**NINE MILE POINT
NUCLEAR STATION**

SUBJECT: Nine Mile Point Nuclear Station
Unit Nos. 1 and 2; Docket Nos. 50-220 and 50-410

License Amendment Requests Pursuant to 10 CFR 50.90: Revisions to the Technical Specifications Design Features Sections to Reflect the Transfer of a Portion of the Nine Mile Point Nuclear Station Site Real Property

EVALUATION OF THE PROPOSED CHANGE

FIGURE 5.1-1
SITE BOUNDARIES
NINE MILE POINT - UNIT 1

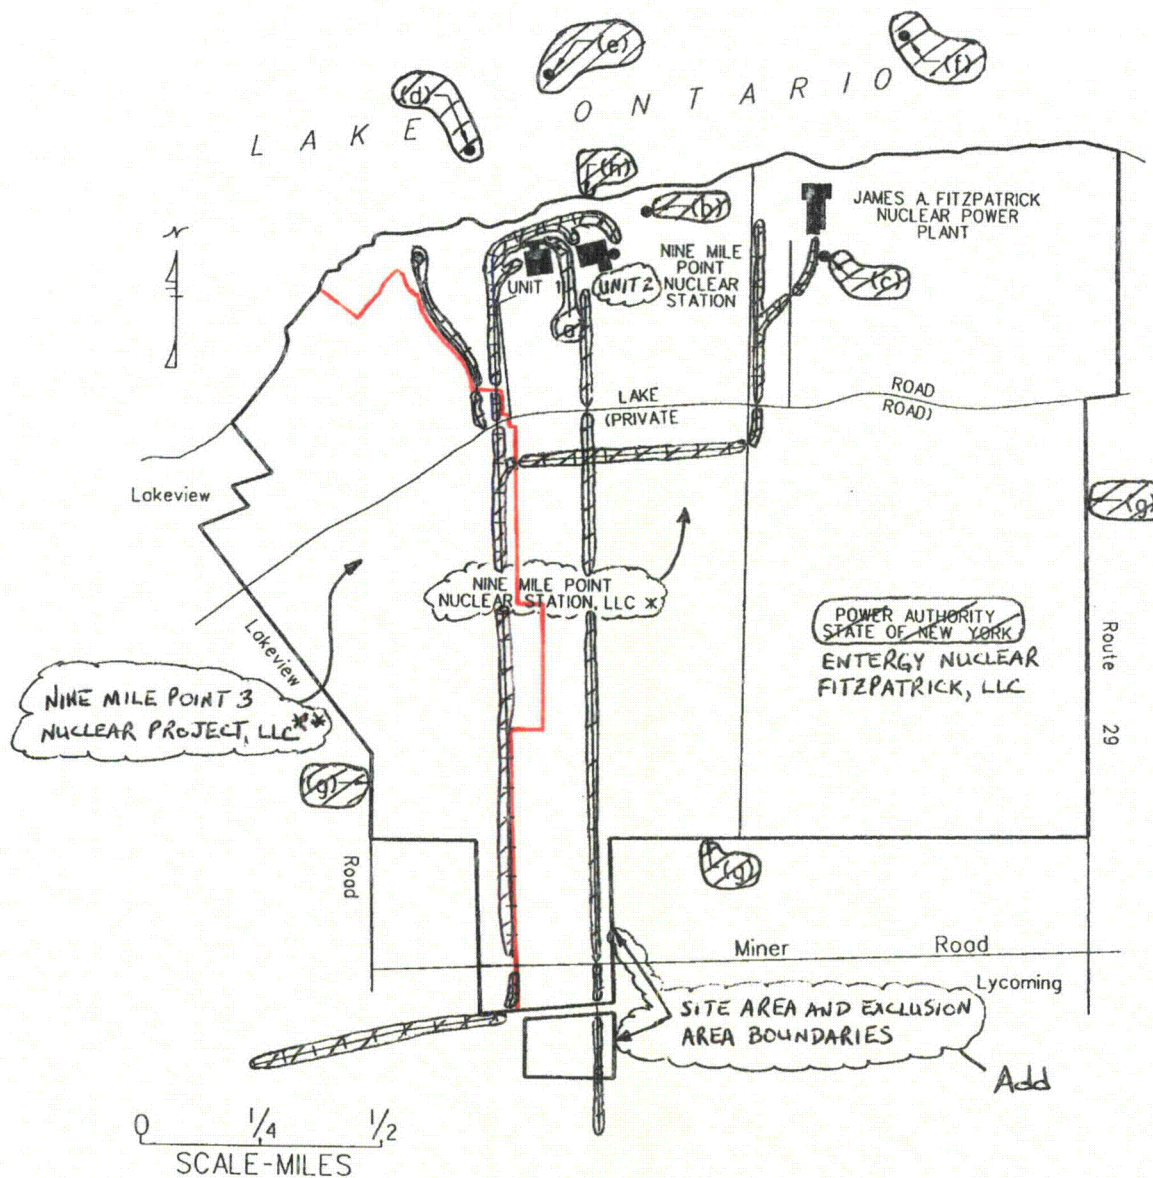
TS Figure 5.1-1, “Site Boundaries, Nine Mile Point – Unit 1,” and associated Notes

3. The reference to “Power Authority State of New York” is replaced with “Entergy Nuclear FitzPatrick, LLC” to reflect the current ownership of JAFNPP.

4. The railroad lines shown on the figure are deleted.
5. Notes (a), (b), and (c) describing the heights of the NMP1, NMP2, and JAFNPP stacks are deleted.

6. The identification of the NMP1, NMP2, and JAFNPP radioactive liquid discharge locations and the associated Notes (d), (e), and (f) are deleted.
7. Note (g), “Site Boundary,” is deleted. A notation identifying the Site Area and Exclusion Area Boundaries is added to the figure.

8. Note (h), “Lake Ontario Shoreline,” is deleted.
9. The unlabeled depiction of the Energy Information Center location and the road leading to this facility are deleted.

10. A vertical line in the center of the figure that serves no apparent purpose is deleted.
11. The “Additional Information” Notes describing the heights above ground level of the NMP2 Reactor Building Vent, the JAFNPP Reactor and Turbine Building Vents, and the JAFNPP Radwaste Building Vent are deleted.

- NMP1 Item 3 and NMP2 Item 1 - On NMP1 TS Figure 5.1-1 and NMP2 TS Figure 4.1-1, the reference to "Power Authority State of New York" is replaced with "Entergy Nuclear FitzPatrick, LLC." This is an administrative change to reflect the current ownership of JAFNPP, which is adjacent to NMPNS and shares the same site boundary.

- NMP1 Item 4 and NMP2 Item 2 - On NMP1 TS Figure 5.1-1 and NMP2 TS Figure 4.1-1, the railroad lines have been deleted. These lines are no longer in use and have been disabled. They are not relevant to the purpose of the figures (i.e., to show the site and exclusion area boundaries and the locations of the plants relative to these boundaries).

- NMP1 Items 5 and 6 - On NMP1 TS Figure 5.1-1, Notes (a), (b), and (c) describing the heights of the NMP1, NMP2, and JAFNPP stacks are deleted, and the identification of the NMP1, NMP2, and JAFNPP radioactive liquid discharge locations and the associated Notes (d), (e), and (f) are deleted. This information was initially added by License Amendment No. 66 (issued on November 2, 1984), which added RETS in accordance with the model RETS provided in NUREG-0473, Revision 2. The RETS were subsequently relocated from the TS to licensee-controlled documents (e.g., the ODCM) by License Amendment No. 176 issued on September 11, 2002. The NMP1 stack height and identification of the NMP1 radioactive liquid discharge location are proposed to be relocated to the NMP1 UFSAR, where the information currently exists. Any changes to this design information must also comply with the requirements of 10 CFR 50.59. If this facility design information were altered in accordance with 10 CFR 50.59, there would not be a significant impact on safety (which is the criterion of 10 CFR 50.36(c)(4) for inclusion in the TS as a Design Feature). Therefore, removing these details from the TS, while maintaining the details in the NMP1 UFSAR, will not impact safe operation of the facility. These details are not required to be in the TS to provide adequate protection of the health and safety of the public.

- NMP1 Items 7 and 8 - On NMP1 TS Figure 5.1-1, Note (g), "Site Boundary," and Note (h), "Lake Ontario Shoreline," are deleted. A notation identifying the Site Area and Exclusion Area Boundaries is added to the figure, thereby providing the same information that is currently in Note (g). The location of the Lake Ontario shoreline is readily apparent and does not need any further identification, and such a note is not included on NMP2 TS Figure 4.1-1. These changes are considered administrative.

- NMP1 Item 9 and NMP2 Item 5 - On NMP1 TS Figure 5.1-1, the unlabeled depiction of the Energy Information Center location and the road leading to this facility are deleted, and on NMP2 TS Figure 4.1-1, the identification of the Nuclear Learning Center, Energy Information Center, and Meteorological Tower locations, and the roads leading to these facilities, are deleted. The locations of these facilities are proposed to be relocated to the NMP1 UFSAR and the NMP2 USAR, where the information currently exists. Any changes to this design information must also comply with the requirements of 10 CFR 50.59. If this facility design information were altered in accordance with 10 CFR 50.59, there would not be a significant impact on safety (which is the criterion of 10 CFR 50.36(c)(4) for inclusion in the TS as a Design Feature). Therefore, removing these details from the TS, while maintaining the details in the NMP1 UFSAR and the NMP2 USAR, will not impact safe operation of the facility. In addition, there are no unrestricted areas within the site boundary that are routinely accessible to members of the public. These details are not required to be in the TS to provide adequate protection of the health and safety of the public.

- NMP1 Item 10 and NMP2 Item 6 - On NMP1 TS Figure 5.1-1 and NMP2 TS Figure 4.1-1, there is a vertical line in the center of the figure that is being deleted. This change is considered administrative, as the line serves no apparent purpose.

- NMP1 Item 11 - On NMP1 TS Figure 5.1-1, the "Additional Information" Notes describing the heights above ground level of the NMP2 Reactor Building Vent, the JAFNPP Reactor and Turbine Building Vents, and the JAFNPP Radwaste Building Vent are deleted. The NMP1 TS only cover operation of NMP1, not NMP2 or a plant operated by another entity. Therefore, it is not appropriate to have design features of another nuclear power plant maintained in the NMP1 TS. Since the NMP1 OL controls the operation of NMP1 only, and Section 2.C.(2) of the OL states that NMPNS shall operate the facility (NMP1) in accordance with the TS, these changes are considered administrative.

** Insert 1

- **** Nine Mile Point Nuclear Station, LLC has easements to access and use the property owned by Nine Mile Point 3 Nuclear Project, LLC for security, emergency preparedness, and site monitoring purposes, by Agreement.

Figure 4.1-1 (Page 1 of 1)
Site Area and Land Portion of Exclusion Area Boundaries

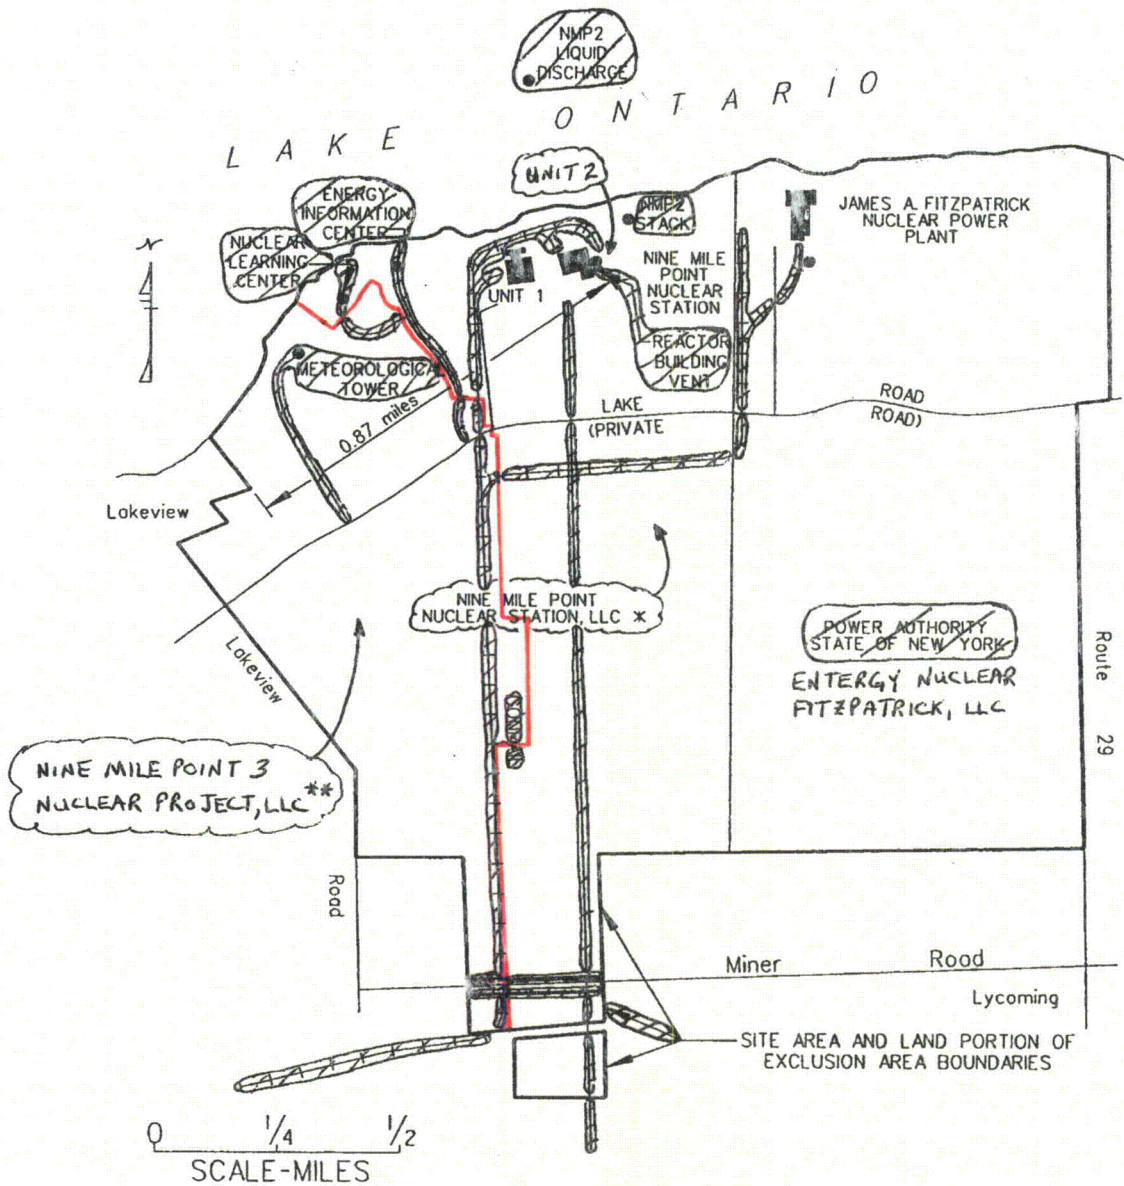
TS Figure 4.1-1, "Site Area and Land Portion of Exclusion Area Boundaries"

1. The reference to "Power Authority State of New York" is replaced with "Entergy Nuclear FitzPatrick, LLC" to reflect the current ownership of JAFNPP.
2. The railroad lines shown on the figure are deleted.
3. Labels for the NMP2 Stack and the NMP2 Reactor Building Vent are deleted.
4. The identification of the NMP2 Liquid Discharge location is deleted.
5. The identification of the Nuclear Learning Center, Energy Information Center, and Meteorological Tower locations, and the roads leading to these facilities, are deleted.
6. A vertical line in the center of the figure that serves no apparent purpose is deleted.

- NMP2 Items 3 and 4 - On NMP2 TS Figure 4.1-1, the labels for the NMP2 Stack and the NMP2 Reactor Building Vent are deleted, and the identification of the NMP2 Liquid Discharge location is deleted. This RETS information was included as part of the original NMP2 TS issued in 1987. The RETS were subsequently relocated from the TS to licensee-controlled documents (e.g., the ODCM) by License Amendment No. 91 (issued on February 15, 2000). The NMP1 stack, reactor building vent, and liquid discharge locations are proposed to be relocated to the NMP2 Updated Safety Analysis Report (USAR), where the information currently exists. Any changes to this design information must also comply with the requirements of 10 CFR 50.59. If this facility design information were altered in accordance with 10 CFR 50.59, there would not be a significant impact on safety (which is the criterion of 10 CFR 50.36(c)(4) for inclusion in the TS as a Design Feature). Therefore, removing these details from the TS, while maintaining the details in the NMP2 USAR, will not impact safe operation of the facility. These details are not required to be in the TS to provide adequate protection of the health and safety of the public.

** Insert 1

- **** Nine Mile Point Nuclear Station, LLC has easements to access and use the property owned by Nine Mile Point 3 Nuclear Project, LLC for security, emergency preparedness, and site monitoring purposes, by Agreement.
